VALIDATION REPORT ON POST-REGISTRATION CHANGES (PRCs)

Title and reference number of the project activity	Title: Sichuan Baishuijiang Duonuo Hydropower Project Reference number: 8916
Process track	<input type="checkbox"/> Prior approval <input checked="" type="checkbox"/> Issuance <input type="checkbox"/> Renewal of crediting period
Version number of the validation report on PRCs	Version 1.0
Completion date of the validation report on PRCs	02/11/2016
Type(s) of PRCs	<input type="checkbox"/> Temporary deviations from the registered monitoring plan, monitoring methodology or standardized baseline <input type="checkbox"/> Corrections <input type="checkbox"/> Changes to the start date of the crediting period <input type="checkbox"/> Inclusion of a monitoring plan to a registered project activity <input checked="" type="checkbox"/> Permanent changes from registered monitoring plan, monitoring methodology or standardized baseline <input type="checkbox"/> Changes to the project design of a registered project activity <input type="checkbox"/> Types of changes specific to afforestation and reforestation project activities

Figure B.3. Diagram of project boundary

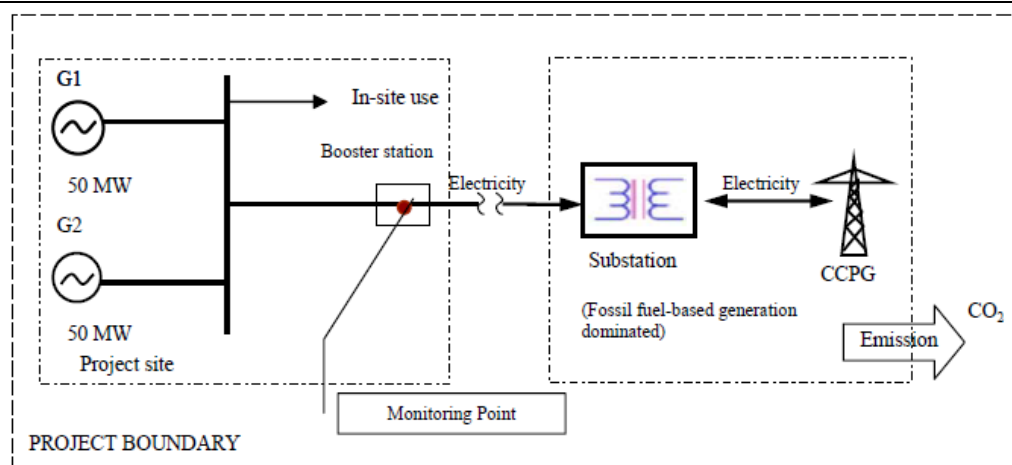
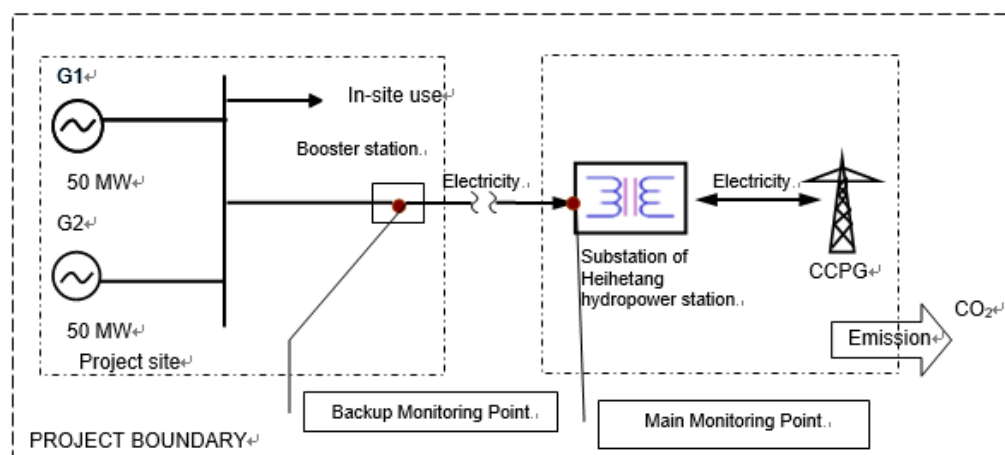
Means of validation	Documentation review, site visit and interview
Findings	By reviewing the Revised PDD (version 3.0, dated 30/10/2016), the validation team is able to confirm that the requested post-registration change to the registered PDD is the location of main meter W1 /3/. The project has deployed two meters (main meter: W1; backup meter: W2) to monitor the electricity exported to the CCPG and imported from the CCPG and then determine the quantity of net electricity supplied to the CCPG. As per the Figure 3 and Section B.7 of the registered monitoring plan /1/, these two meters would be installed at the outlet of on-site substation of the project as follows:

The registered PDD was completed on 14/12/2012 while the project was still undergoing construction and was put into operation on 26/04/2013 /6/. According to the PPA signed between the project owner and the grid company /5/, the main meter W1 is actually installed at the inlet of substation of Heihetang hydropower station and the backup meter is installed at the outlet of on-site substation of the project as planned. The registered PDD is therefore revised with regard to this requirement pertained to the PPA in the Figure B.3.-1 and Section B.7 as follows:

This change of main meter only refers to the meter location, and does not involve any impact on applicability and monitoring requirements of the applied methodology /9/. As defined in the registered PDD, the accuracy of W1 and W2 would reach 0.5s or above /1/. The accuracy of the meters are in fact calibrated 0.2s as shown in their calibration reports /8/. The current data information flows, QA/QC procedures, data cross-checking methods, etc. modified due to this post-registration change do not have material differences with the ones previously described in the registered PDD /1/. Furthermore, the emission reductions of the project are calculated conservatively in consideration of that the transmission line losses are deducted from the quantity of net electricity supplied to the CCPG. Hence, it is validation team's opinion that the accuracy of calculation of emission reductions of the project is still ensured.

This permanent change of main meter W1's location is taken place in compliance with the requirements of PPA /5/. Hence, this change does not require prior approval by the Board as confirmed in accordance with the appendix to the PS /11/.
